DOMINION ENERGY KEWAUNEE, INC.
KEWAUNEE POWER STATION
LICENSE AMENDMENT REQUEST 263; LOAD DROP ANALYSIS FOR SPENT
FUEL CASK HANDLING OPERATIONS

**LICENSE AMENDMENT REQUEST 263:
LOAD DROP ANALYSIS FOR SPENT FUEL CASK HANDLING OPERATIONS**

**MARKED-UP UPDATED SAFETY ANALYSIS REPORT PAGE
(FOR INFORMATION)**

Figure 1
NAC Secure Lift System
and Stack-Up Configuration

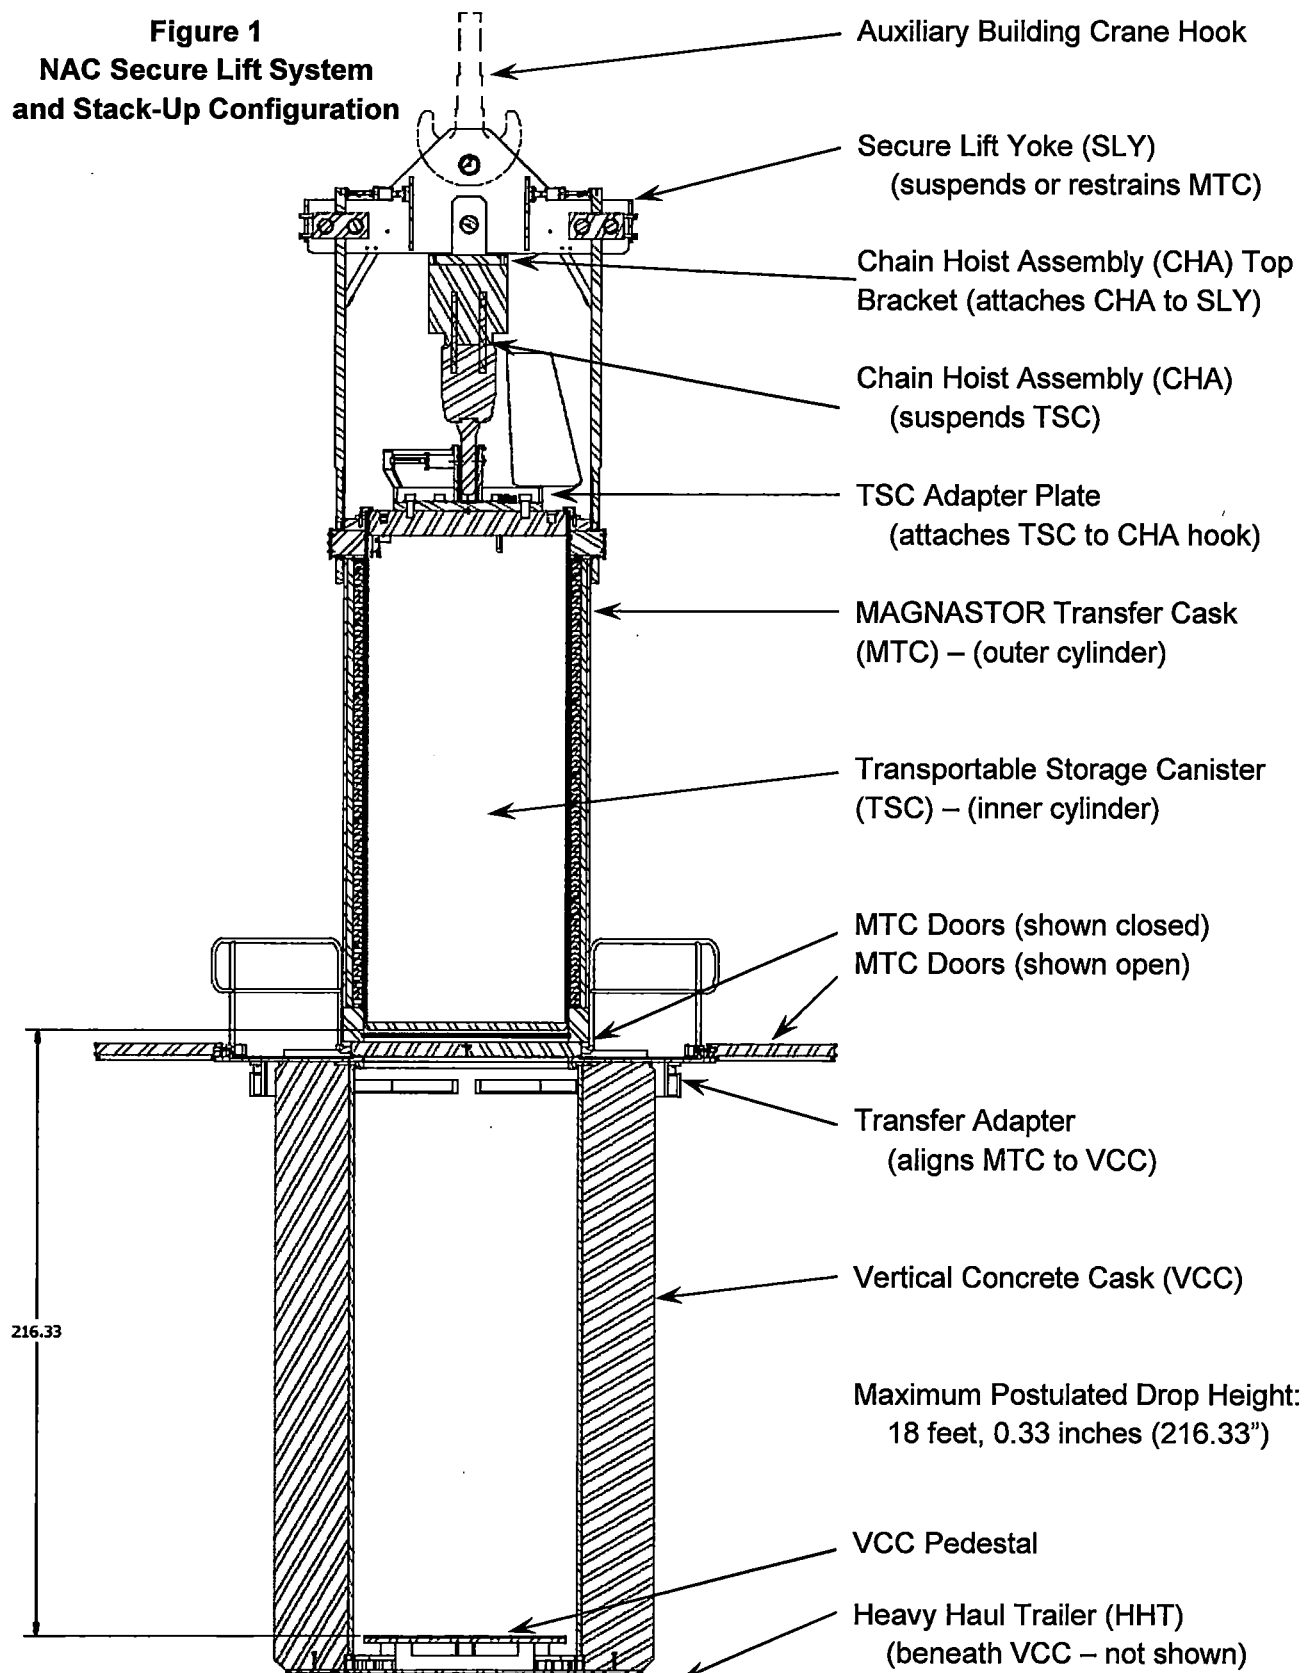
A diagram of the NAC secure lift system is shown in Figure 1. The NAC secure lift system consists of two integrated components, the secure lift yoke and the air driven chain hoist assembly. The secure lift yoke is used to move the MAGNASTOR transfer cask (MTC) from the cask decontamination area to the truck bay and position the MTC in the stack-up configuration atop its vertical concrete cask (VCC). The chain hoist assembly is used to raise/lower the loaded TSC into or out of its VCC while in the stack-up configuration on the Heavy Haul Trailer. The chain hoist assembly is also used to handle the TSC adapter plate away from the spent fuel pool.

The chain hoist assembly does not conform to NUREG-0612 guidance as a single failure proof lifting device. It is used in the truck bay of the auxiliary building to raise and lower the TSC after a stabilized stack-up configuration is achieved. The stack-up configuration occurs about 28 feet away from the edge of the spent fuel pool, which precludes any physical contact between the TSC and the spent fuel pool in the highly unlikely event of a postulated TSC drop while using the chain hoist assembly. The chain hoist assembly is also used in the cask decontamination area and in the truck bay for handling the TSC adapter plate. The chain hoist assembly is not used to handle the TSC over or around the spent fuel pool.

Although the chain hoist assembly is not a single failure proof lifting device, it is conservatively designed with enhanced safety features that reduce the possibility of a load drop. Specifically:

- The chain hoist assembly has a design rated load of 110 tons, which is more than two times larger than the estimated MAGNASTOR system component load of 49 tons and two times the rated maximum critical load (MCL) of 55 tons. Since the system is designed for a safety factor of 5 times the design rated load, the overall factor of safety to the MCL is 10 to 1.

- The chain hoist assembly meets the requirements of ASME NUM-1, Type IB, critical load handling hoist standards.
- The chain hoist assembly has redundant braking comprised of an air actuated disc type brake (primary) and drive train braking (redundant).

- The chain hoist assembly has a controlled lowering speed of no greater than 9 inches per minute (field test results confirm 6 inches per minute lowering speed).

- The chain hoist assembly has redundancy on two-blocking protection via an upper limit switch (primary) and an air stall feature (redundant).
- The chain hoist assembly has been load tested to a minimum of 300% of the 55 ton MCL rating, which exceeds the requirements of ASME NUM-1.

- **Diagram of Stack-Up Configuration and Heavy Haul Trailer**
- **Diagram of Auxiliary Building Cross Section**

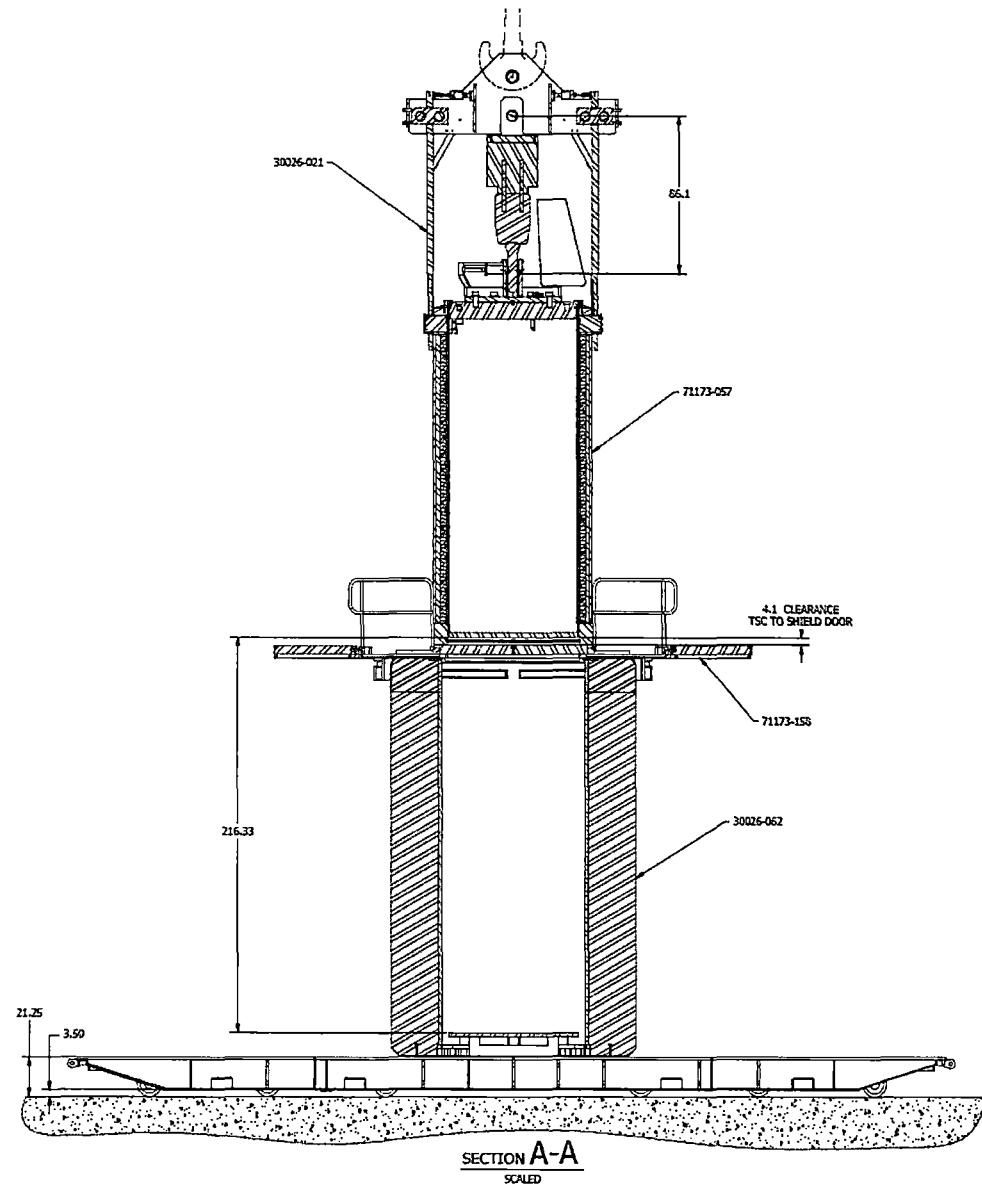
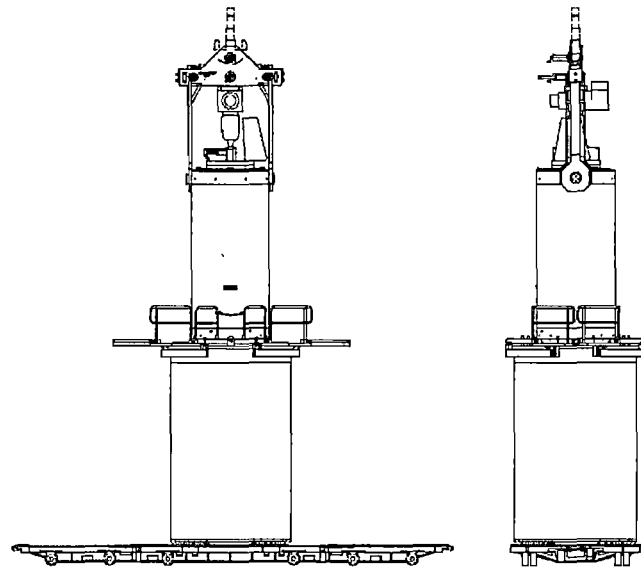
- The VCC sits on a HHT during the transfer operation. The HHT is a uniquely designed trailer that is used to transport the empty or loaded VCC in a vertical position into and out of the auxiliary building. The height of the HHT for transfer operations is procedurally controlled so as to limit the height of the HHT deck to less than 24 inches above the floor surface (maximum VCC lift height as specified in the MAGNASTOR FSAR). Although not designed or credited as an impact limiting device, the HHT is maintained in position beneath the VCC consistent with the load drop analysis.

- The use of the chain hoist assembly is both procedurally restricted and physically constrained such that a loaded canister cannot be suspended higher than a maximum height of 216.33 inches (18 feet, 0.33 inches) above the VCC pedestal (as shown in Figure 1). Therefore, the maximum potential drop height for the loaded TSC is 216.33 inches (18 feet, 0.33 inches). This maximum lift height is bounded by the analyzed drop height of 220 inches.

- The gap between the bottom of the HHT box beam and top surface of the concrete floor is 3 to 4 inches.

Other input parameters used in the load drop analysis were based on design features of the affected equipment, which are controlled by other requirements (e.g., CoC, technical specifications, etc.). Detailed diagrams of cask handling configurations and areas, including the HHT, are provided in Attachment 4.

Diagram of Auxiliary Building Cross Section (showing cask handling areas)

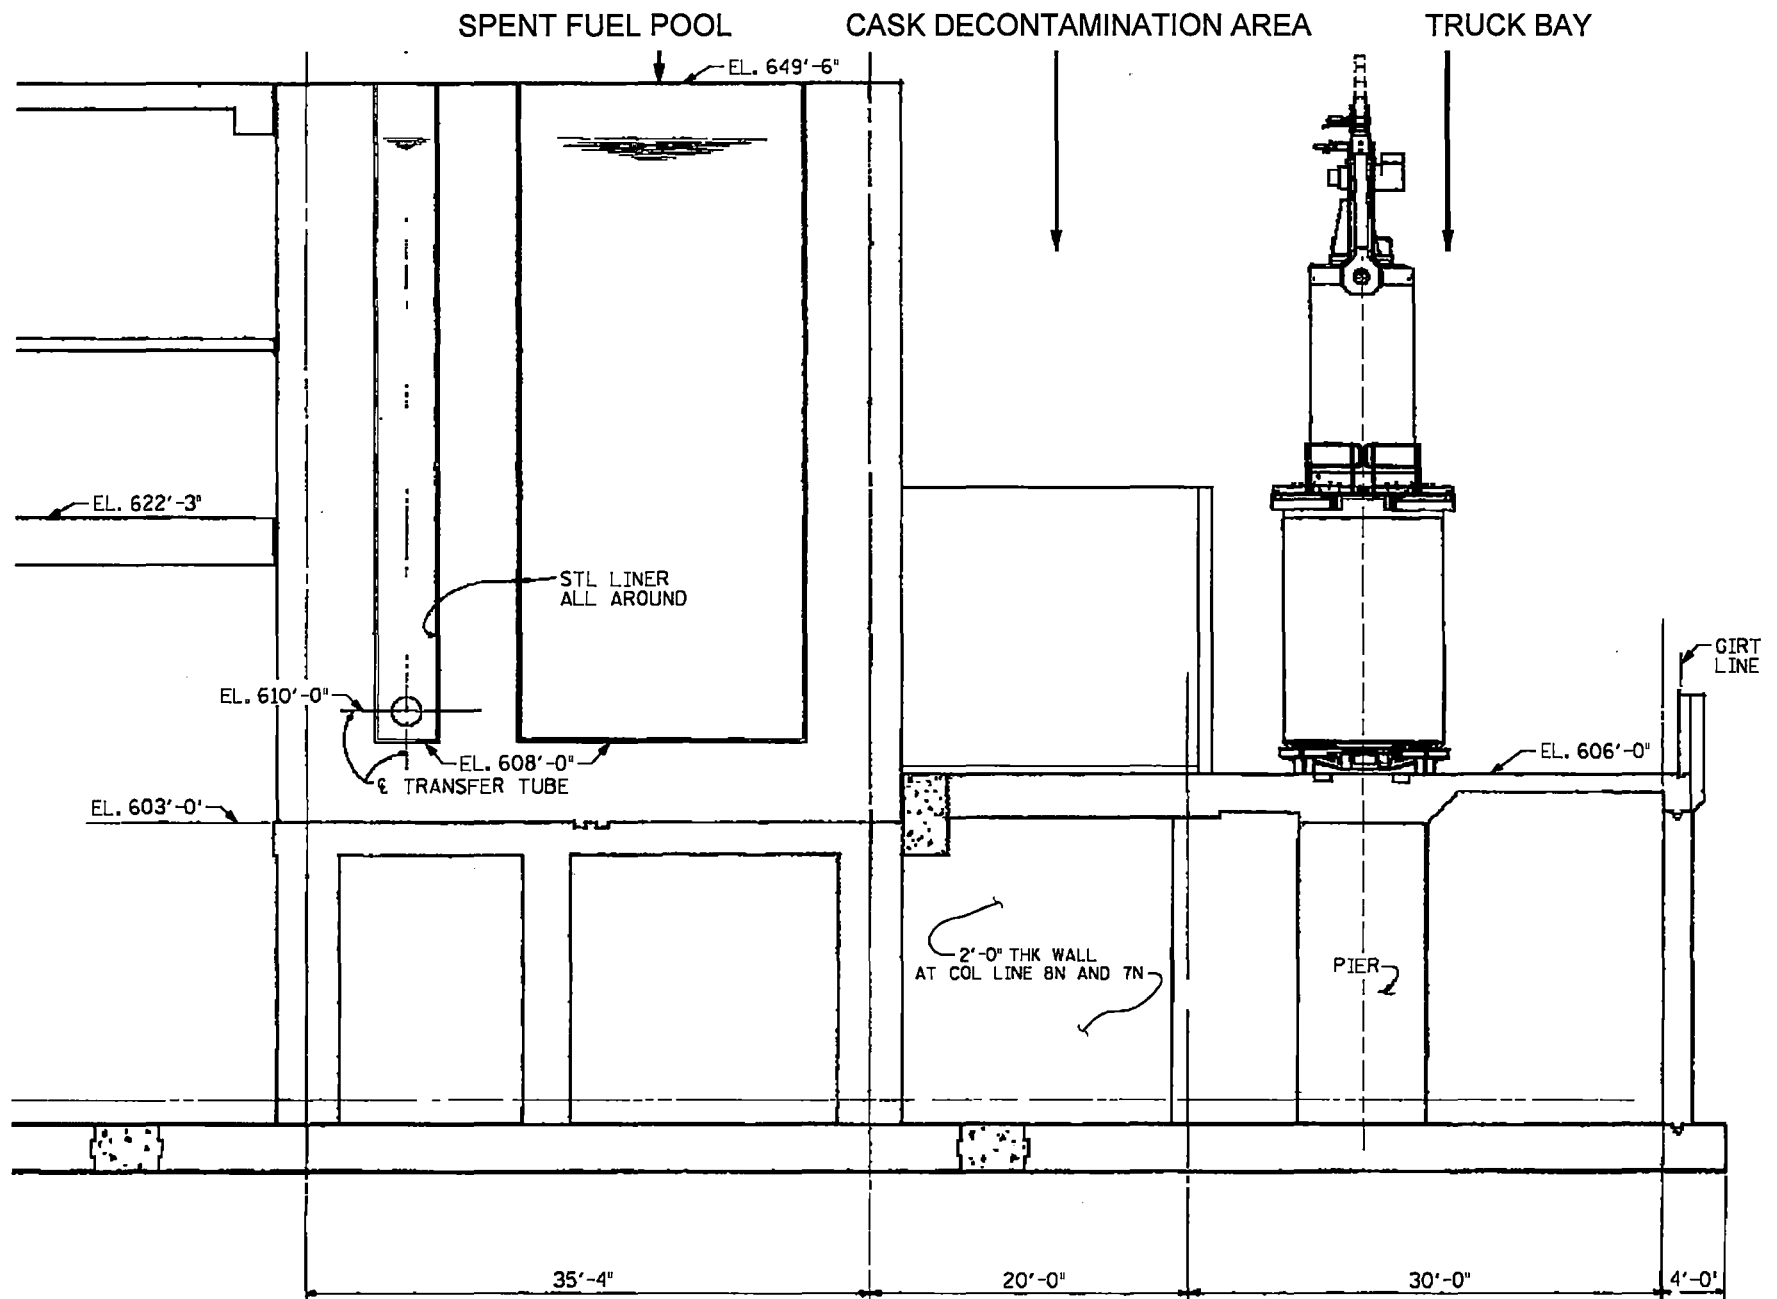
The chain hoist assembly is not used to handle a TSC over or around the spent fuel pool. The stack-up configuration occurs about 28 feet away from the edge of the

spent fuel pool, which precludes any physical contact between the TSC and the spent fuel pool structure in the unlikely event of a postulated TSC drop. The spent fuel pool was demonstrated to withstand the tributary structural effects of a postulated drop of the loaded TSC inside the VCC and meet the acceptance criteria of applicable industry standards (Enclosure 2).
